MY1 FINAL MONITORING REPORT
Banner Branch Mitigation Project
Stokes County
Roanoke River Basin
CU 03010103

DMS Project # 100080
DMS Contract # 7610 and 7701
DMS RFP # 16-007405
USACE Action ID Number SAW-2018-01760
DWR Project # 18-1154
Calendar Year of Data Collection: 2021

RE: WLS Responses to NCDEQ DMS Review Comments for Task 7 Submittal, Draft Monitoring Year 1 Report for the Banner Branch Mitigation Project, DMS Full-Delivery Project ID #100080, Contract #s 7610 & 7701, Roanoke River Basin, Cataloging Unit 03010103, Stokes County, NC

FIGURE
1a

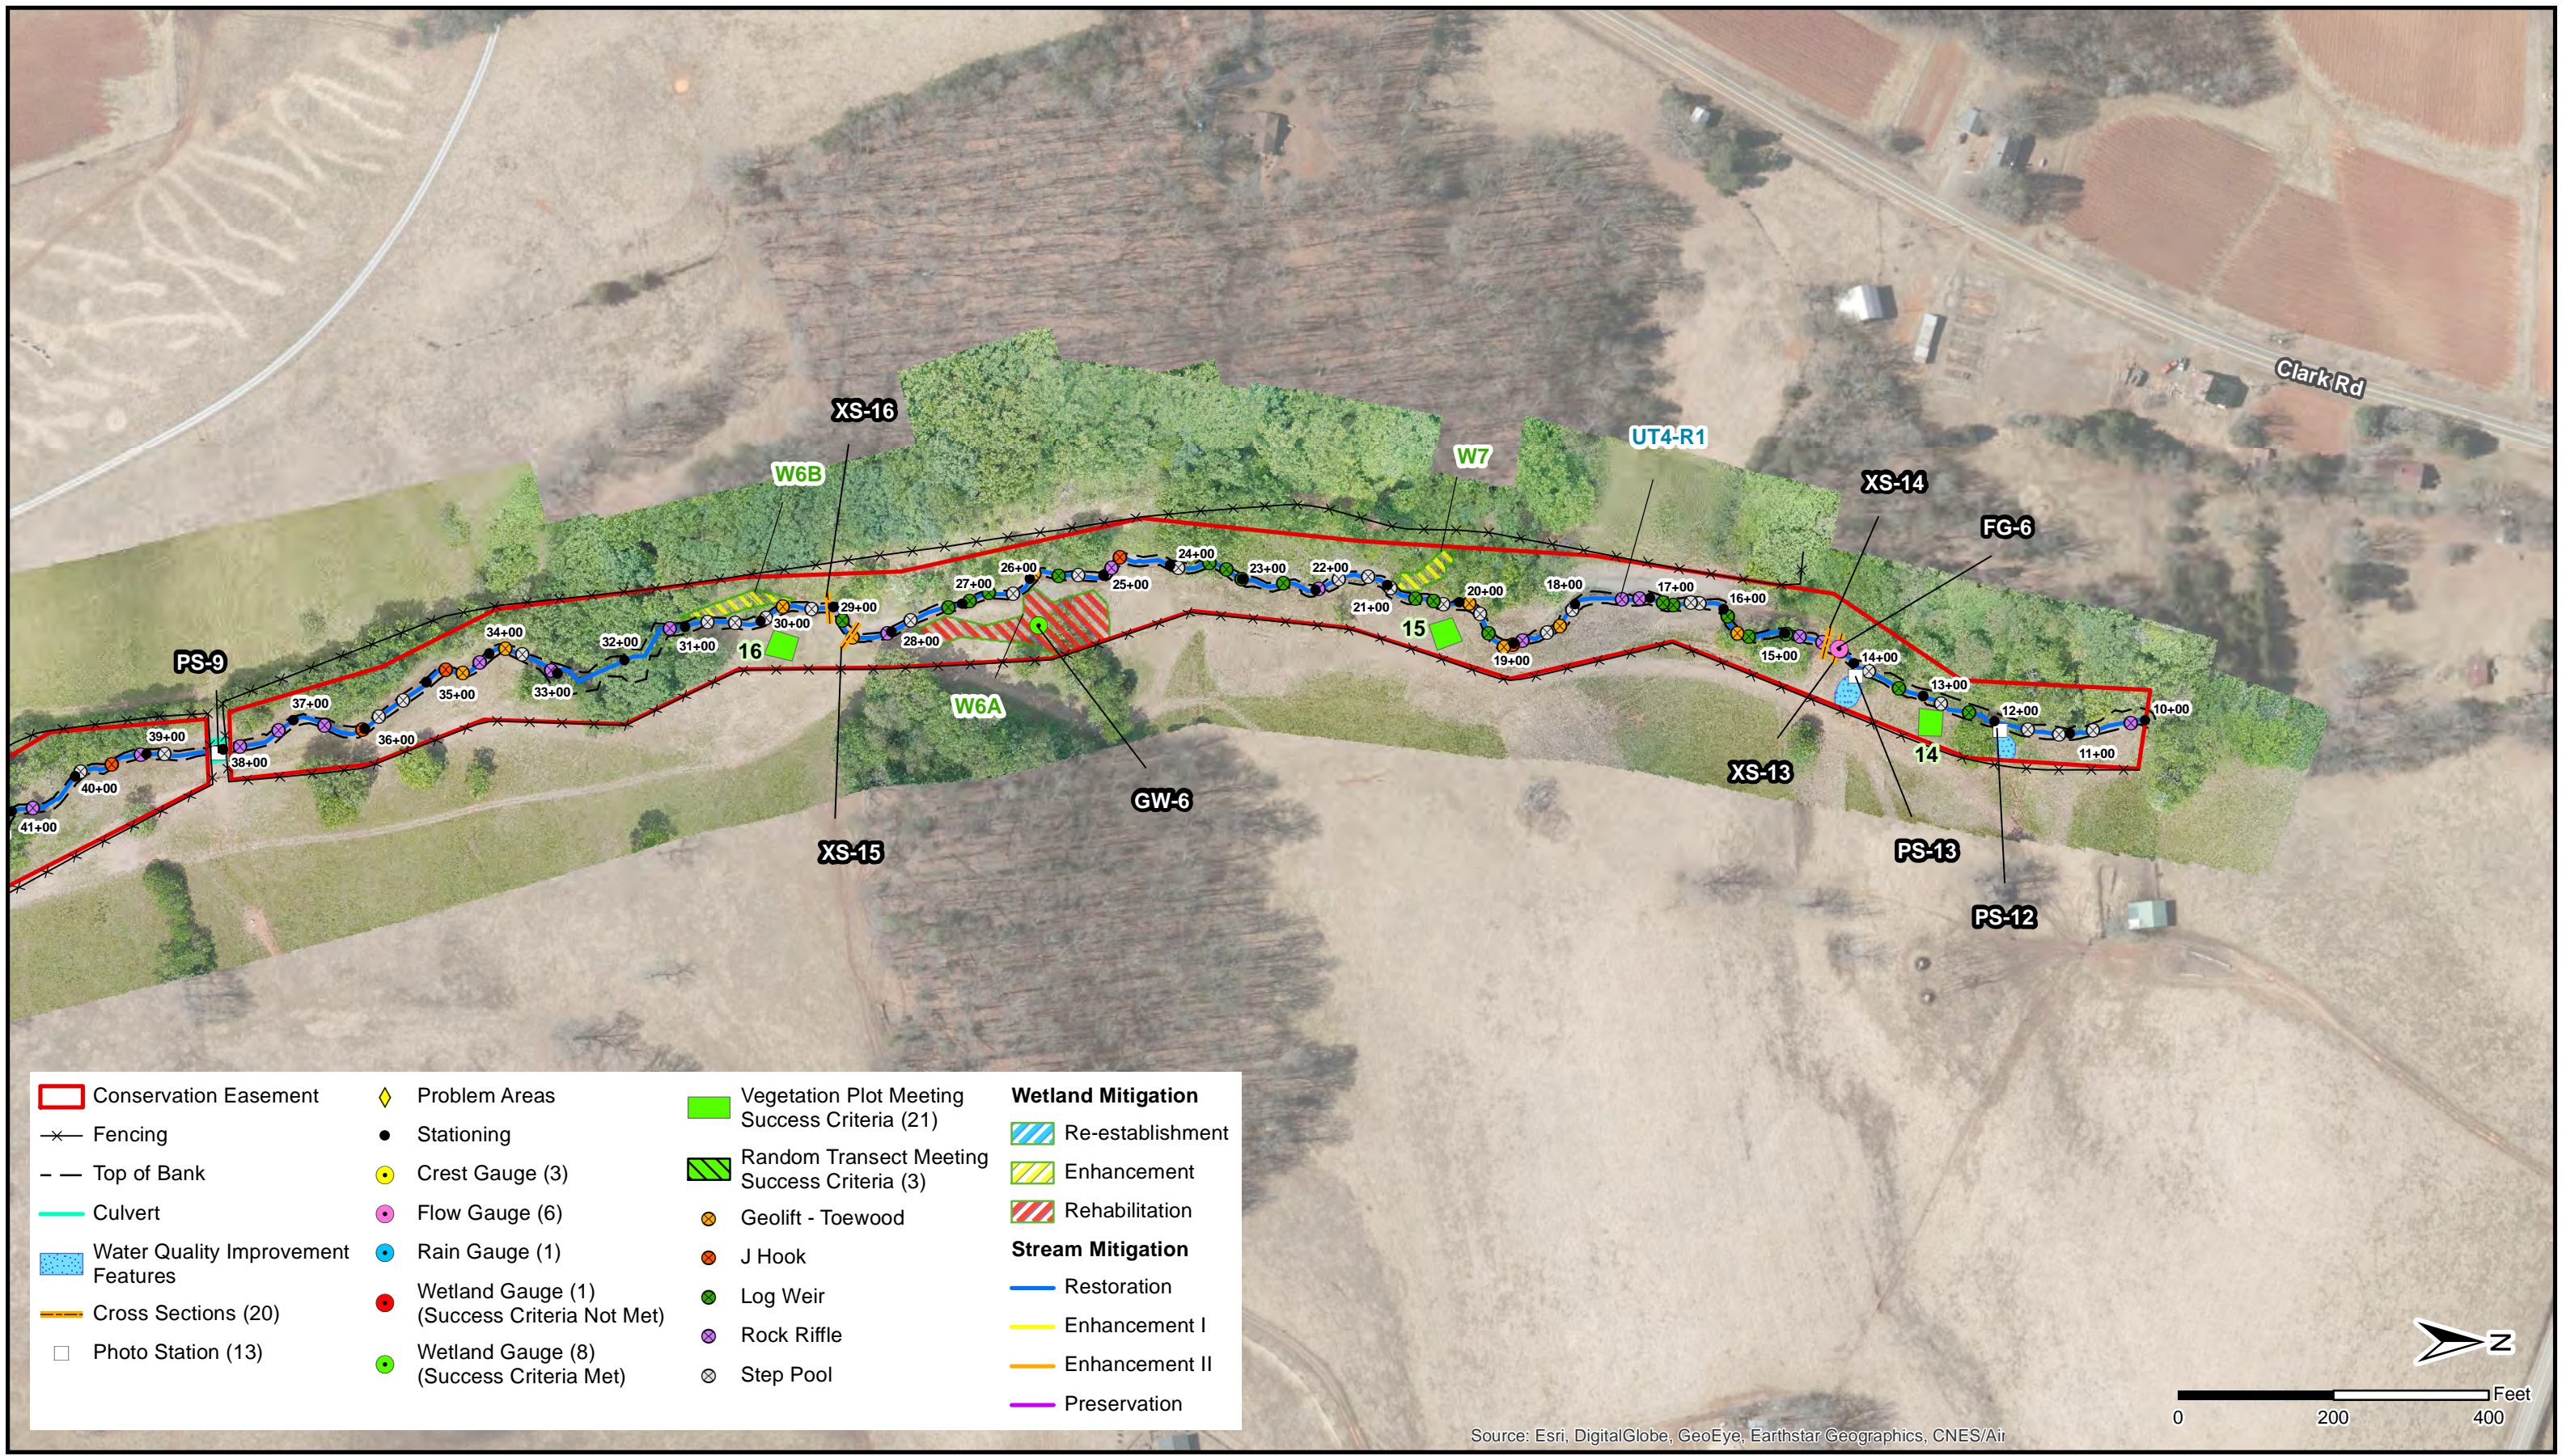
7. **Gate locations were not indicated on the redline drawings. Please confirm that the site has adequate safe access points for regulatory and stewardship staff.** Response: There is adequate safe access points for regulatory and stewardship staff. There are 18 access gates on the project site. WLS has provided the gate locations on the CCPV Figure 1a.

Cross-Section 17 (UT4-R1 - Riffle) MY1

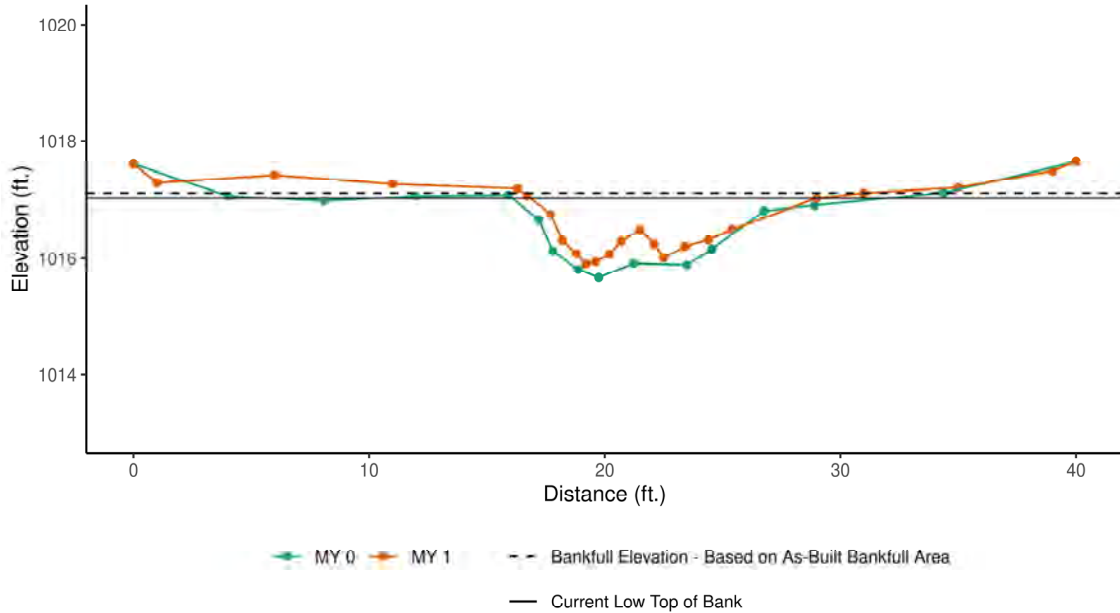
3. UT4 R1 XS17 cross section data and photo indicates that there could be a mid-channel bar forming. Is this the case or is it a debris jam that may flush through (hard to tell with certainty in the photo)? Response: A small mid-channel bar has formed on a woody riffle. We expect overtime this bar will flush out with storm events. There is no evidence of bank instability in this area.

Cross-Section 19 (UT4-R2 - Pool) MY1

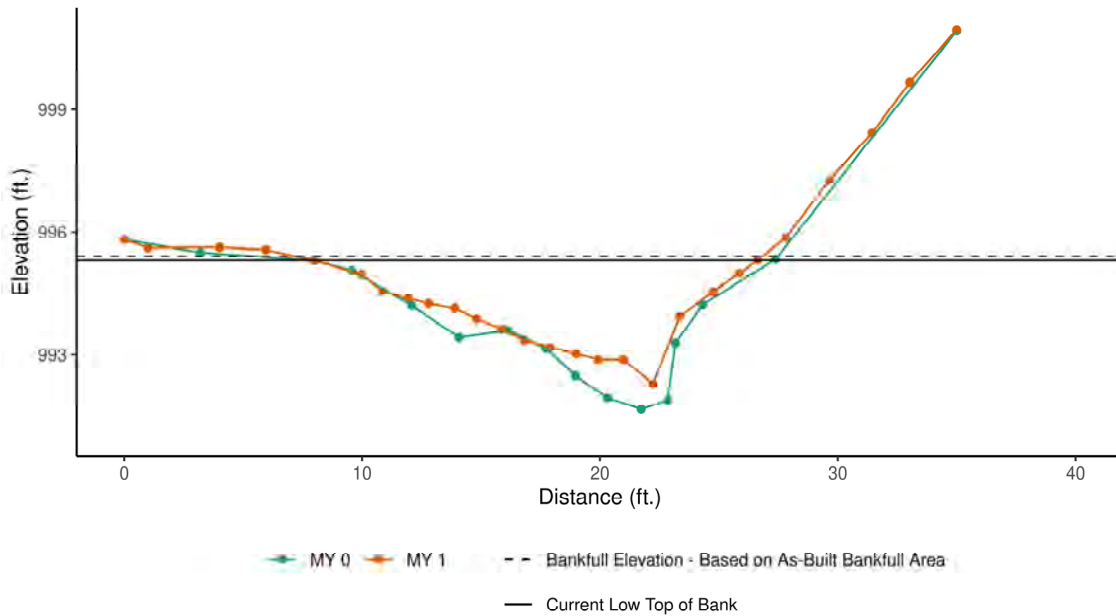
4. **Please label UT3 on the CCPV.** Response: UT3 has been labeled on CCPV.
5. **UT4-RS, XS 19 appears to have a debris jam or beaver dam. Please confirm that this was removed.** Response: There is no debris jam or beaver dam on UT4-R2. This was just debris and a poor camera angle. There is currently no debris jam in this area.
6. **It was noted that flow gauge 3 on UT2 was shifted down stream. In the video footage it appears that the upper portion of this channel is dry. Please supplement the flow data with additional photos documenting flow in future monitoring reports.** Response: The flow gauge was installed more upstream than proposed in the mitigation plan and is well above the upper one-third of the reach. This is an intermittent reach and the gauge data will provide evidence of flow. WLS will provide photo documentation of flow on UT2 during the twice a year visual assessment.

2. **Photo UT4-R2 XS19 Upstream shows an in-stream drop. Do you know if it's a debris jam or beaver dam?** Response: Please see response to USACE #5. This is a poor photo angle and there is not an in-stream drop, debris jam or beaver dam on UT4-R2. This was just debris and a poor camera angle. There is currently no debris jam in this area.

Banner Branch GW-2 (W8a)

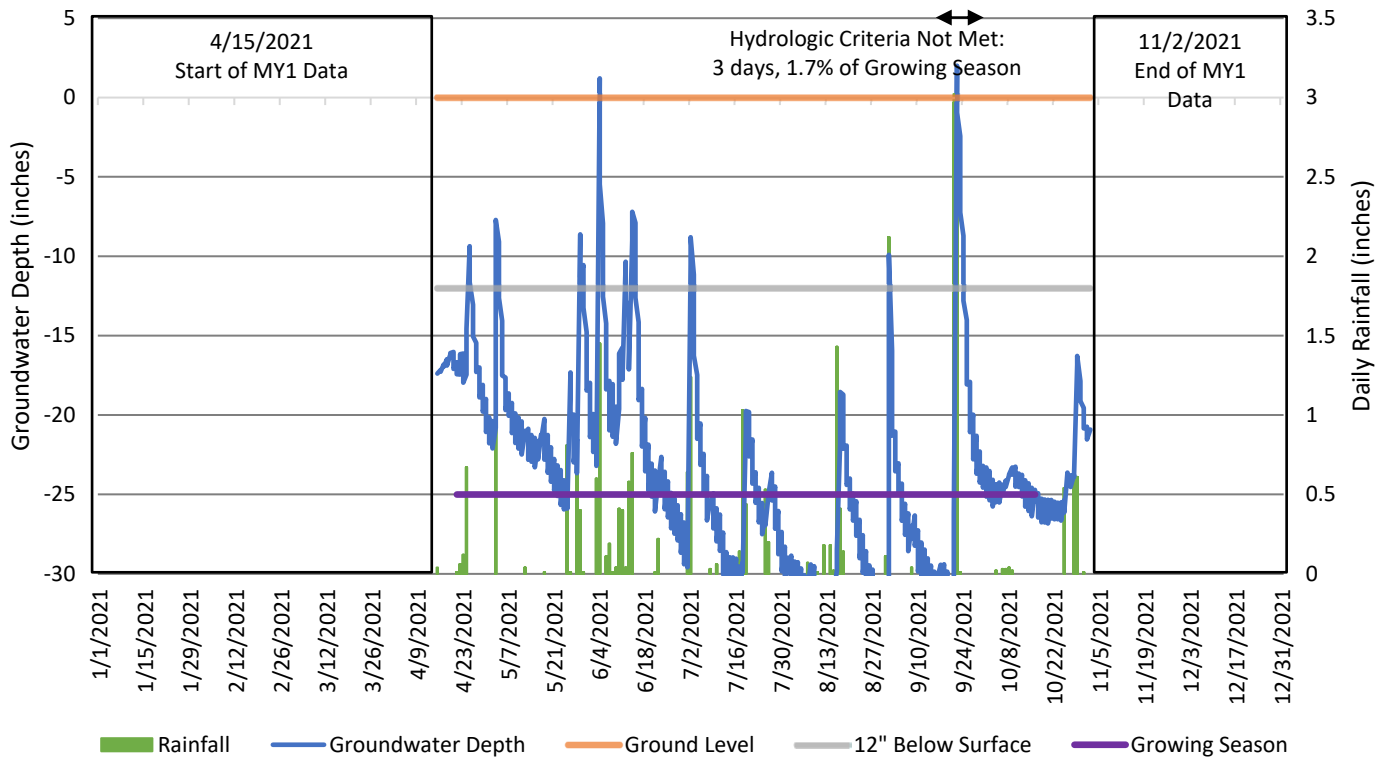
2. Section 4.3 - Presumably the reference to WG-2 should be GW-2? While we understand that it is very early in the project, does WLS have any thoughts on the cause of the hydroperiod of only 1.7% at this gauge's location? Response: WG-2 has been corrected to GW-2. For W8A, the vertical profile of Banner Branch was gradually raised to tie into BB-R1/UT1-R3 confluence at station 43+11 thereby

increasing the frequency of overbank flows and restoring hydrology. WLS expects hydrology in this area to increase over the next couple of years.
